Re: North Hollywood to Pasadena BRT 30% Submittal Documents

TERA has reviewed the 30% Submittal documents (dated 1/27/2025) and thank Metro's project team for design adjustments in response to community feedback in Eagle Rock from ourselves and others, including efforts to maintain existing Al Fresco dining areas, to accommodate delivery access to Trader Joe's, and to provide more efficient pick-ups and drop-offs for Dahlia Heights Elementary School.

Loading Zones between Maywood and Caspar:

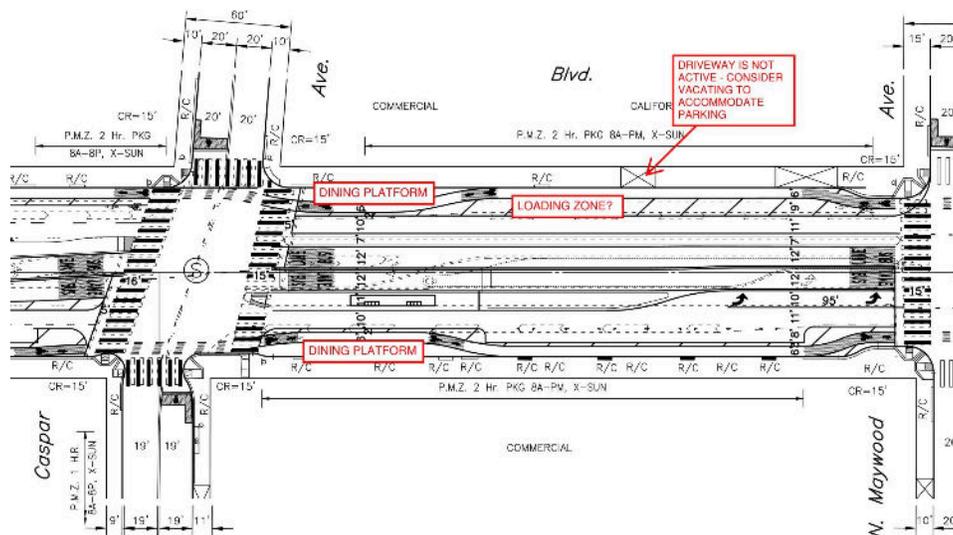
On the north side of Colorado between Caspar & Maywood there is a need for vehicle pick-ups & drop-offs for an existing education business (Mathnasium). If space for vehicle drop-offs is not provided, it will encourage drivers to park and idle within the provided bike lanes or to block the general travel lane. Sheet SS-ERW-104 shows a large buffered area at this location. Is it possible to incorporate a loading area within this area to accommodate this need? Please consider working with the City of Los Angeles and the adjacent business, Z Cars, to determine whether the existing non-operational mid-block driveway can be vacated in order to accommodate needed parking spaces/loading zones.

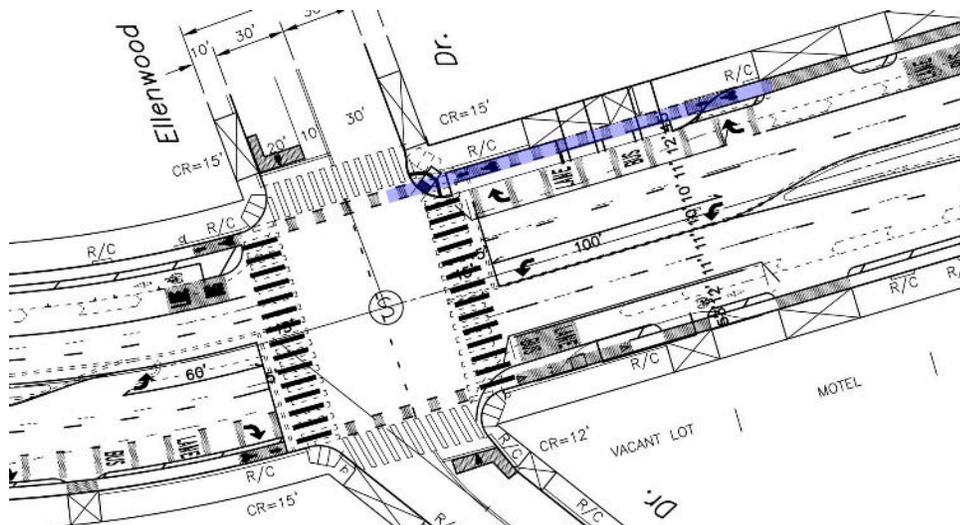
2. The westbound bikeway approaching Ellenwood Drive appears to show a minimum-width sidewalk level bikeway at a local bus stop that shares a 4' wide 45° curb ramp with pedestrians. This is unacceptable and unsafe. Should a curb ramp be provided for both pedestrians and people on bikes at this location, it should provide bi-directional 90° curb ramps or a larger fan ramp, and should provide a minimum of 8' in ramp width in the direction of travel along Colorado Boulevard.

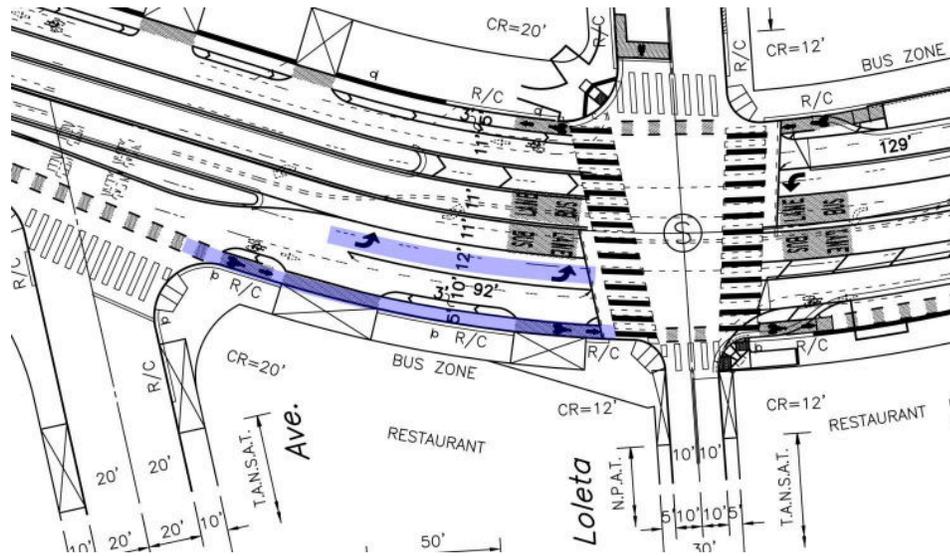
- Between Floristan and Loleta eastbound (sheet SS-ERE-102) there is a 12' wide turn pocket provided. Please consider reducing the width of this turn pocket in order to provide additional width for the undersized curbside bike lane.

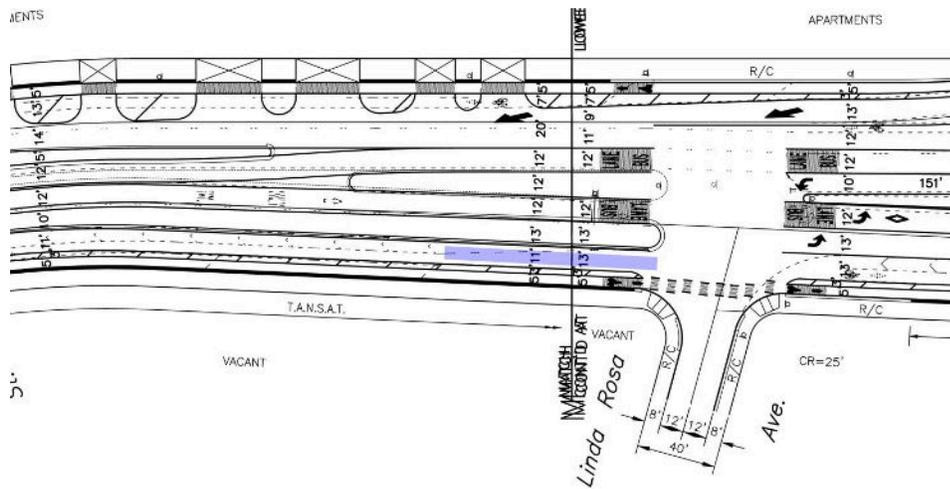
- At Linda Rosa Avenue eastbound (sheet SS-ERE-103), inconsistent 11' & 13' travel lane widths are shown at matchline M. Please consider reducing the 13' travel lane to 11' in order to provide a larger width curbside bike lane
